GULF STATES UTILITIES COMPANY

River Bend Station-Unit 1
Docket No. 50-458

Enclosed is the Gulf States Utilities Company (GSU) response to Safety Evaluation Report (SER) Confirmatory Item #19 - Hydrogen Control (SER Section 6.2.5, Page 6-32/33.) Attachment 1 contains the GSU endorsements for various Hydrogen Control Owners Group (HCOG) submittals. These letters should be utilized to provide background and reference material for SER Confirmatory Item #19. Attachment 2 contains a revision to the Request for Additional Information (RAI) on the Hydrogen Ignition System (HIS) transmitted to W. J. Cahill (GSU) by A. Schwencer (Nuclear Regulatory Commission - NRC) on December 2, 1983 and supercedes the original GSU response from J. E. Booker (GSU) to H. R. Denton (NRC) dated December 30, 1983 (GSU Letter No. RBG-16679).

REQUEST FOR ADDITIONAL INFORMATION FOR USE IN THE EVALUATION OF
THE HYDROGEN IGNITION SYSTEM FOR THE RIVER BEND STATION, UNIT 1
MARK III CONTAINMENT

E & DCR P21.763
 PAGE 5 OF 15

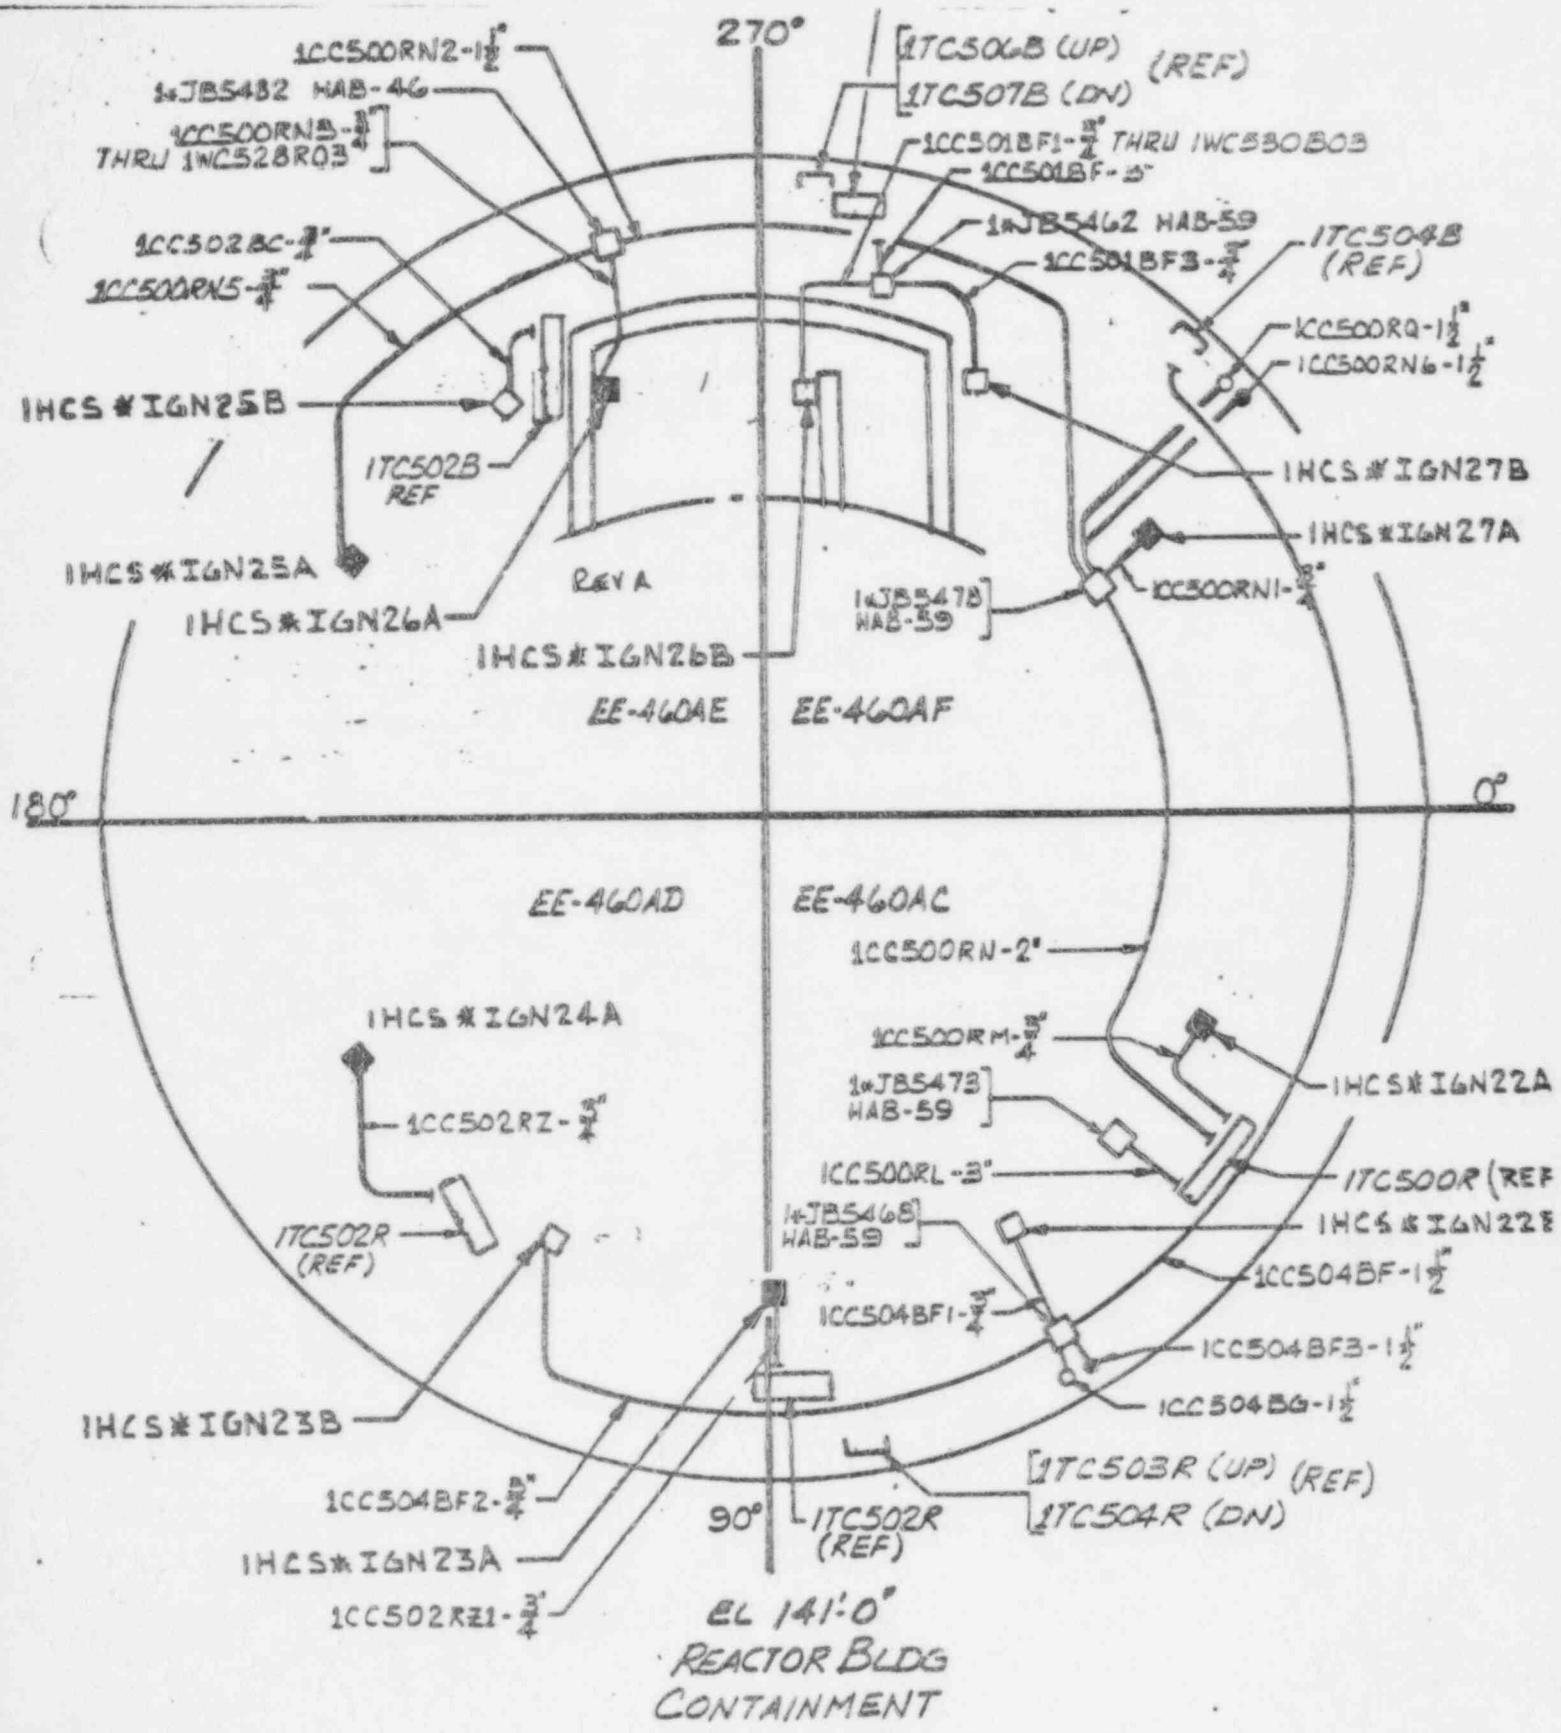
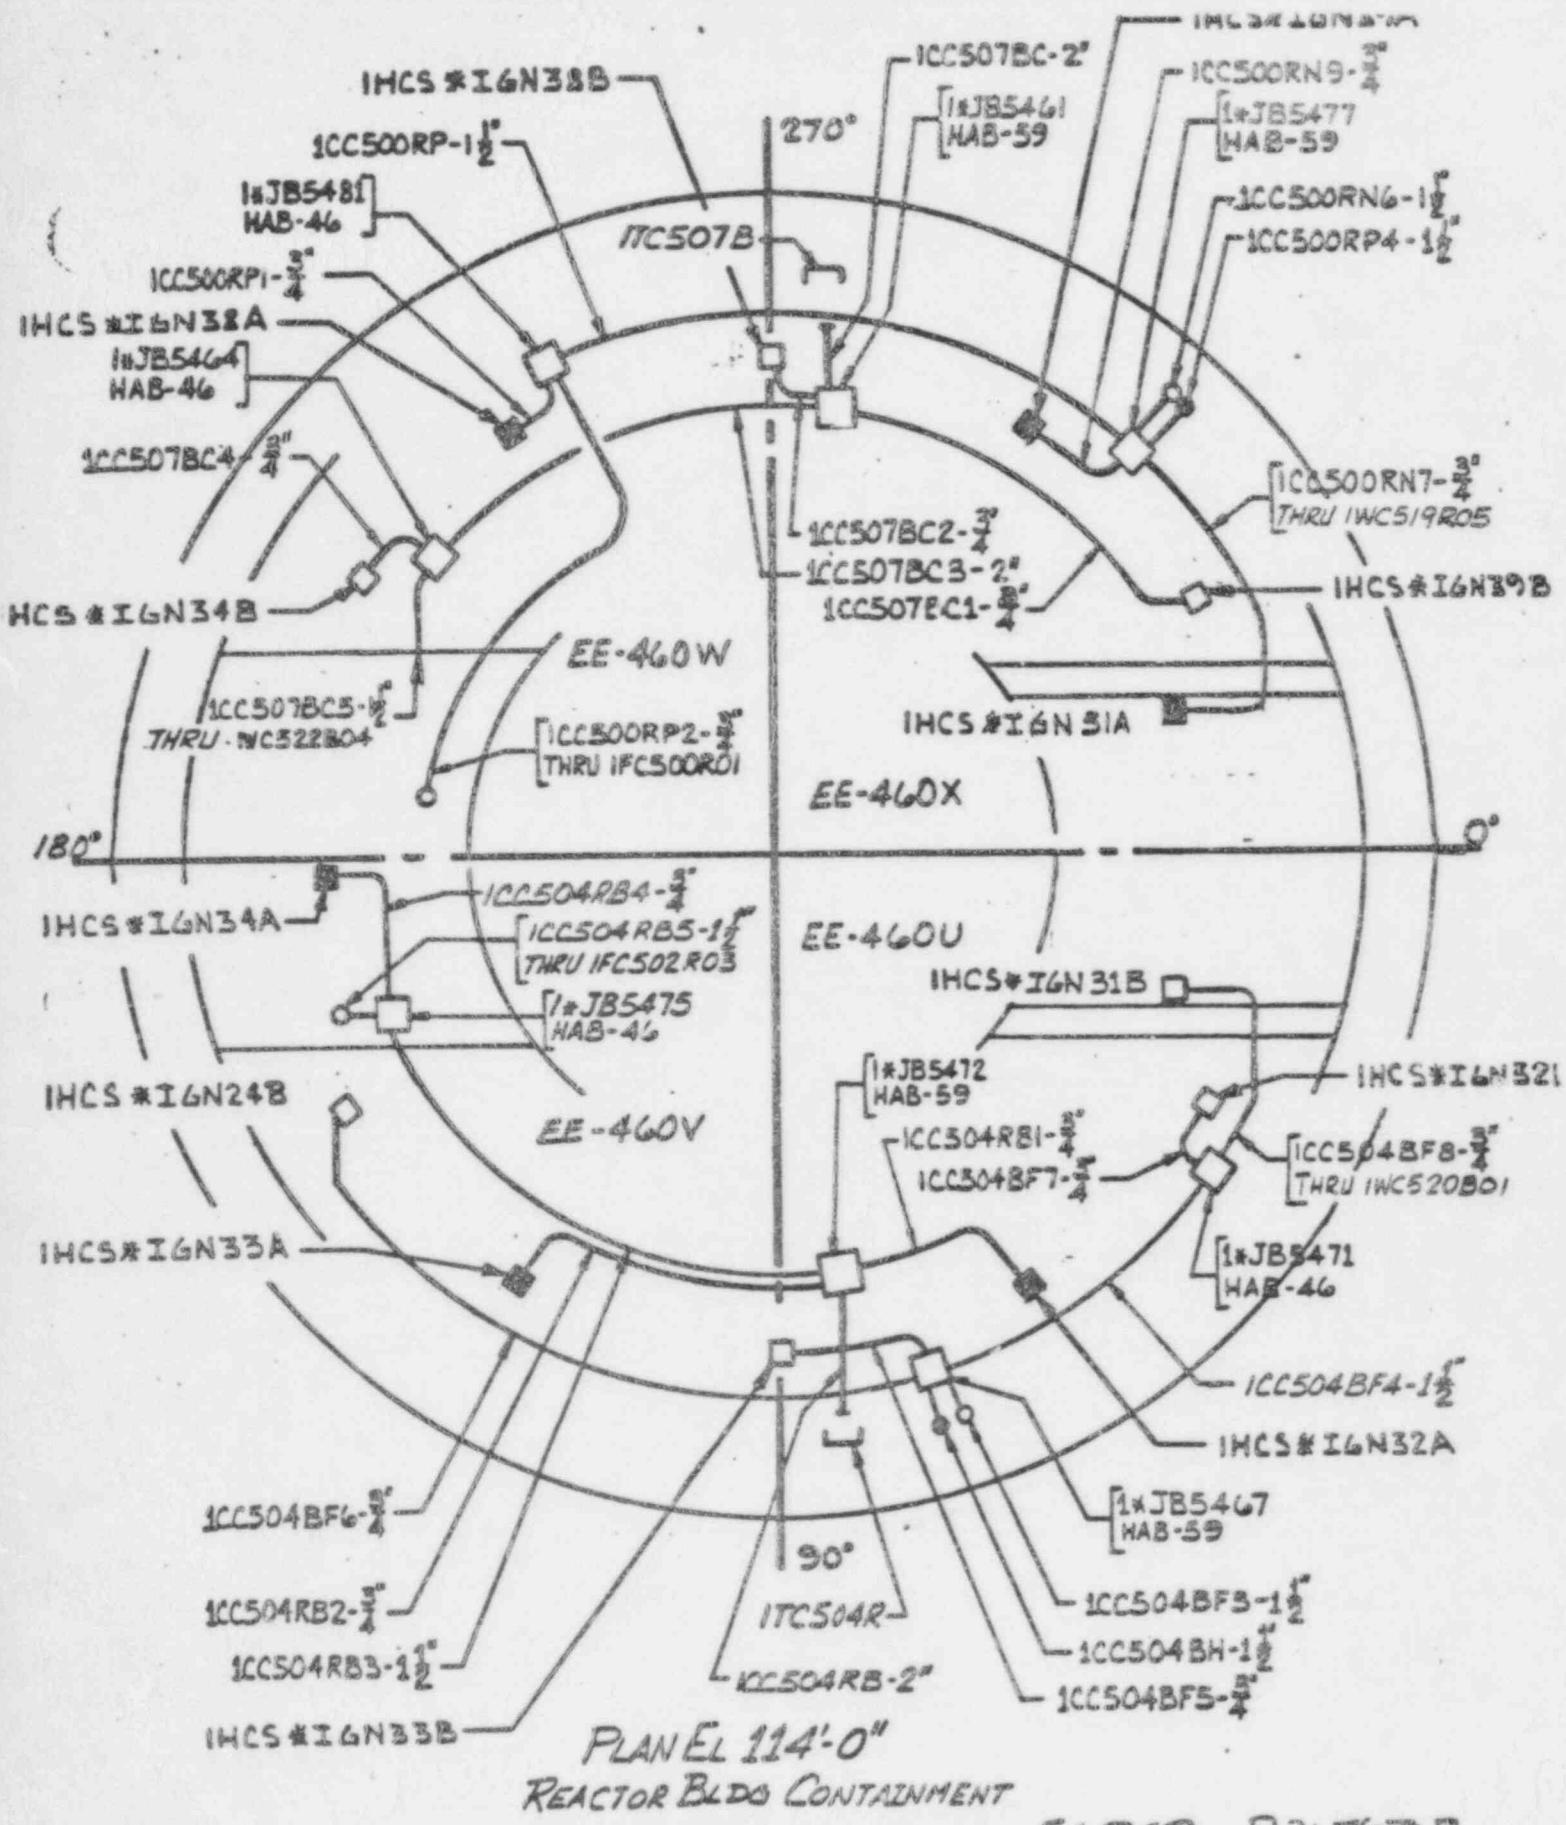
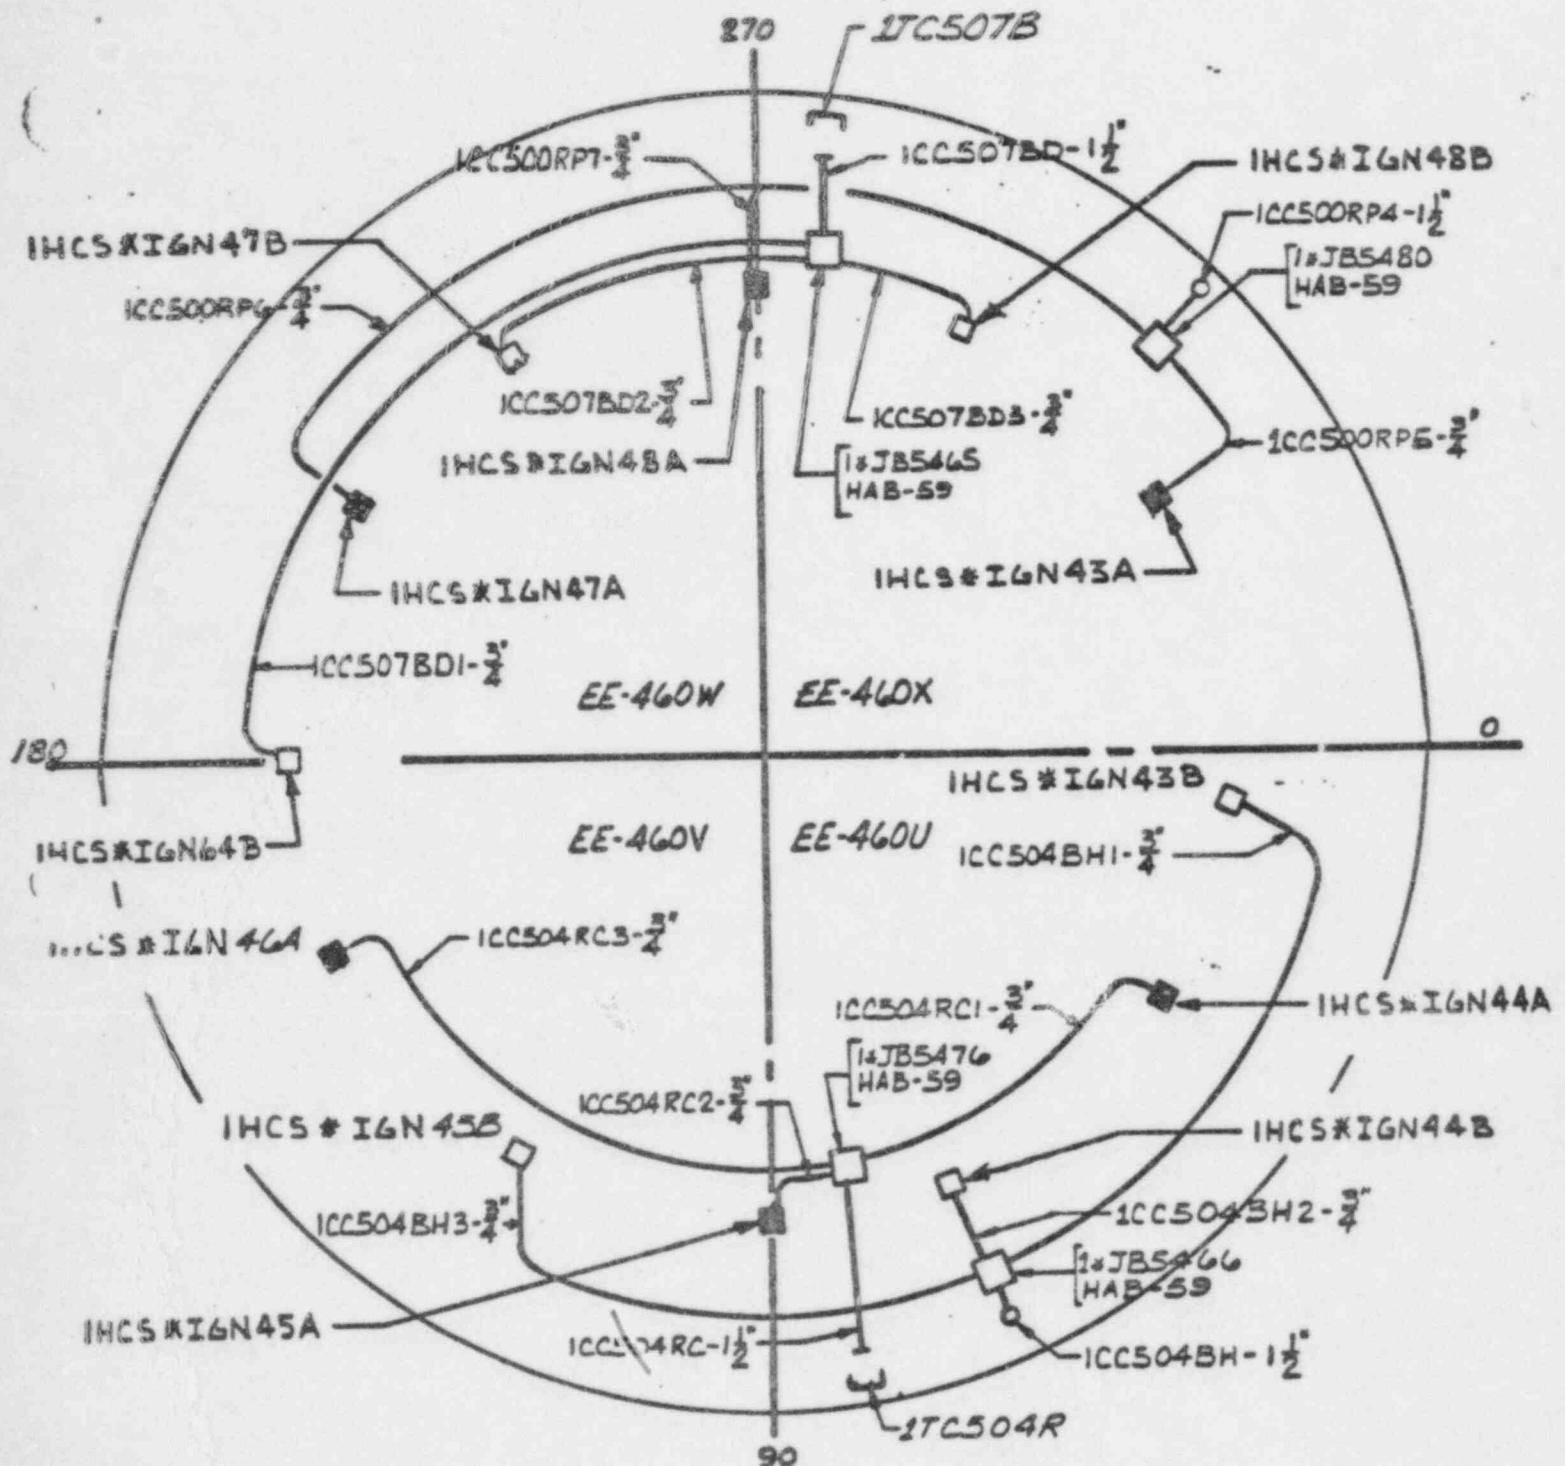
16 DWGS EE-46OU, V, W, X, AC, AD, AE, AF, AJ, AK & AX ARE REVISED ADDING CONDUITS, JUNCTION BOXES, AND LOCATING HYDROGEN IGNITERS AS SHOWN ON PAGES 3 THRU 14.
